**RE: Sage Plaza
1125 Snow Vista Blvd SW
Grading & Drainage Plans
Engineer's Stamp Date: 07/07/23
Hydrology File: M09D012**

**RE: 1125 SNOW VISTA BLVD. SW
GRADING PLAN - RESPONSE TO COMMENT**

SAGE PLAZA
1125 SAGE PLAZE BLVD
FUTURE GRADING AND
DRAINAGE BASIN MAP.

ENGINEER'S SEAL   RONALD R. BOHANNAN P.E. #7868	SAGE PLAZA		DRAWN BY RMG	
	1125 SAGE PLAZE BLVD		DATE 07/03/2023	
	FUTURE STORM DRAIN PLAN		DRAWING 2020073 CRB	
	 TIERRA WEST, LLC 5571 MIDWAY PARK PL NE ALBUQUERQUE, NEW MEXICO 87109 (505) 858-3100 www.tierrawestllc.com		SHEET # C3	
JOB # 2020073

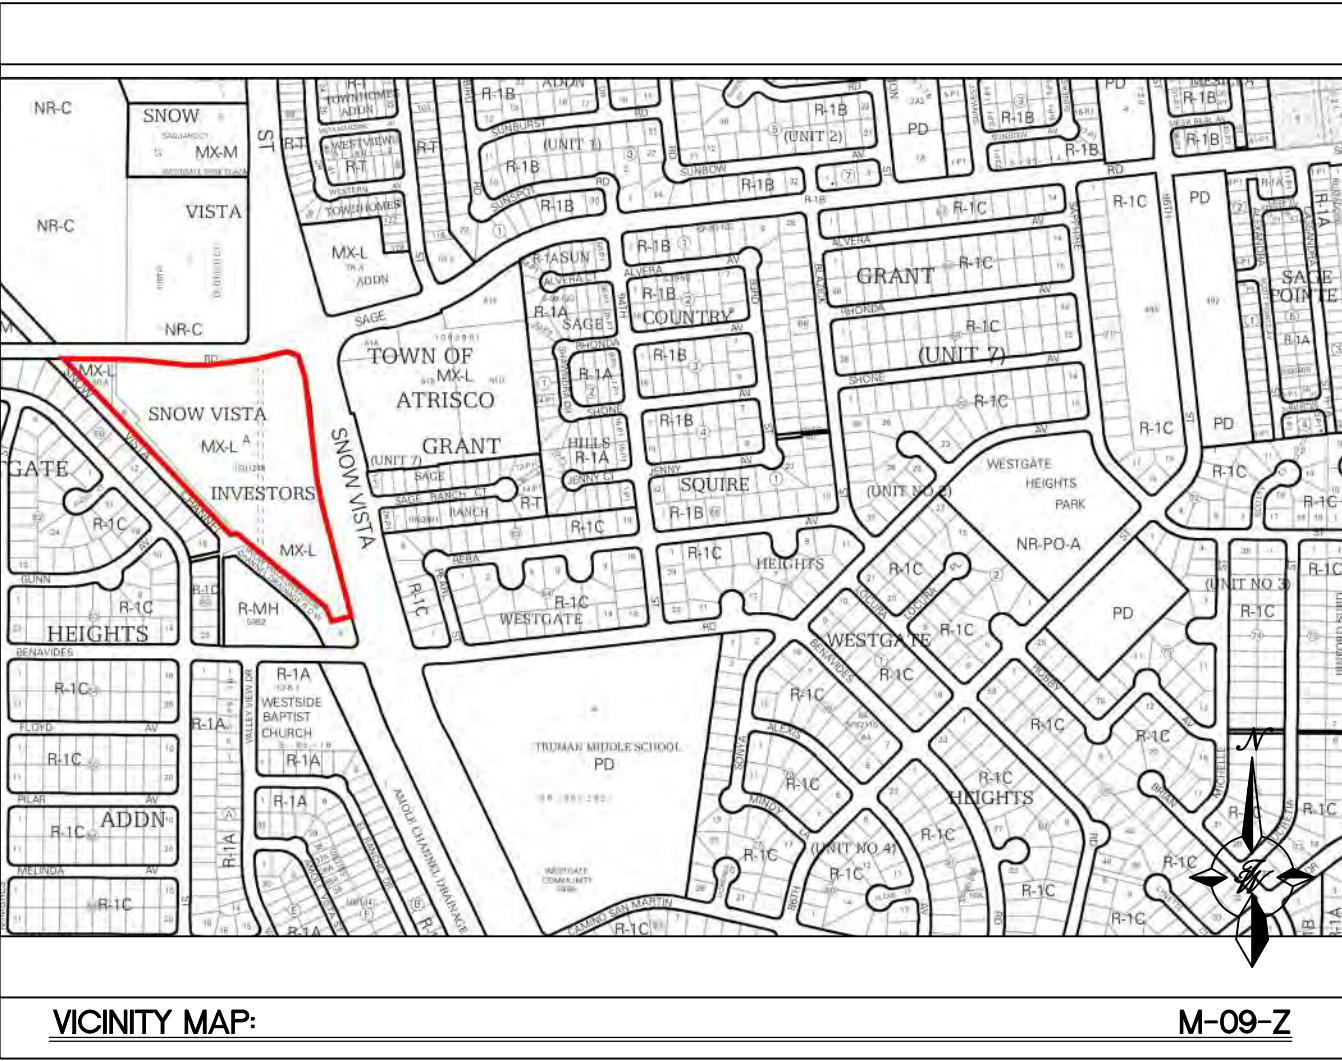
1. Please revise the storm pipe layout. For lots A, C, D, & E, each lot drains to the SE corner of their respective lot along Snow Vista. It will be impossible for drainage to go up hill and connect to the current proposed storm pipe. But the proposed pipe that is shown along the east side of Lot B can be place but it will only handle the drainage for that lot. This is the reason that the engineer of Lot A was proposing a ditch along Snow Vista.

Response: Lots A, C and D will surface flow to the SE corner of their respective lots where storm water can be routed into a storm water quality pond using alley gutters and grade breaks for example and as water rises past the storm water quality volume the water can be diverted to the proposed storm drain pipe using drainage basin inlets in the storm water quality ponds installed within landscaping beds on their respective lots. Storm water from lots B and E can be routed to the southern most tip of their lots where the water can also be diverted into storm water quality ponds and tie to the proposed storm drain pipe using basin inlets as shown on the attached future grading and drainage master plan.
